Access Compliance Report

Public Rights-of-Way (Curb Ramps)

Intersection ID: 16974	Main Street: PROVIDENCE_RD	Cross Street: SCOTLAND_AV	Location: SE
ADA ID: DFB454A68F5E	Ramp Type: PerpDiag	Initial Pass/Fail: Fail	Overall Compliance: No
Severity Score: 25			
Codes/Mitigation Info/Possible Solution		Field Measurements/Component Compliance

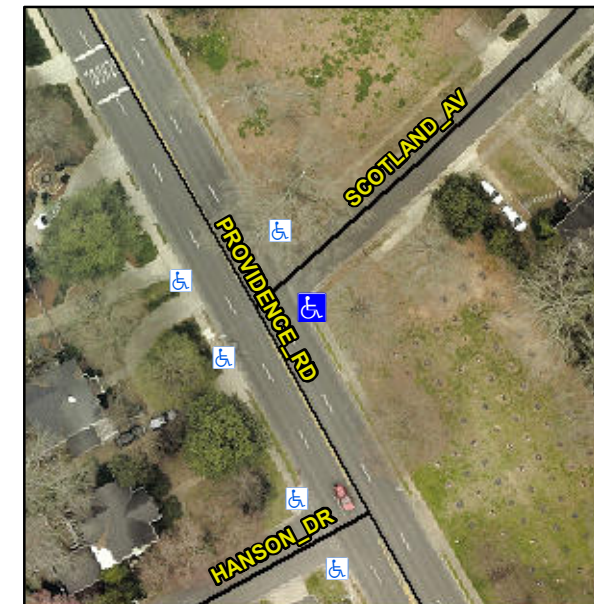
Not Found, R304.2.2, R304.5.3

Compliance	Description	Data	Compliance	Description	Data
N/A	Ramp Length (in)	64.0	No	Ramp Slope (%)	11.5
Yes	Ramp Width (in)	48.0	No	Ramp XSlope (%)	5.9
N/A	Flare Type LT	N/A	N/A	Flare Type RT	N/A
N/A	Flare Slope LT (%)	N/A	N/A	Flare Slope RT (%)	N/A
N/A	Flare Traversable LT?	N/A	N/A	Flare Traversable RT?	N/A
N/A	Landing Length (in)	N/A	N/A	DWS Provided?	N/A
N/A	Landing Width (in)	N/A	N/A	DWS Contrast?	N/A
N/A	Landing Slope (%)	N/A	N/A	DWS Length (in)	N/A
N/A	Landing X Slope (%)	N/A	N/A	DWS Full Width?	N/A
N/A	Landing Curb? (Y/N)	N/A	N/A	DWS Offset (in)	N/A
N/A	Shared Landing?	N/A			
N/A	Gutter Ponding?	N/A	N/A	Gutter Slope (%)	N/A
N/A	Gutter Lip Ht (in)	N/A	N/A	Gutter X Slope (%)	N/A
N/A	Painted X Walk1?	No	N/A	Painted X Walk2?	No
	X Walk 1 Direction	To NW		X Walk 2 Direction	To SW
N/A	X Walk 1 Width (in)	N/A	N/A	X Walk 2 Width (in)	N/A
	X Walk 1 Slope (%)	2.8		X Walk 2 Slope (%)	3.7
	X Walk 1 X Slope (%)	6.4		X Walk 2 X Slope (%)	2.0

Remove & Replace Curb Ramp With Two New Directional Ramps or Equivalent.
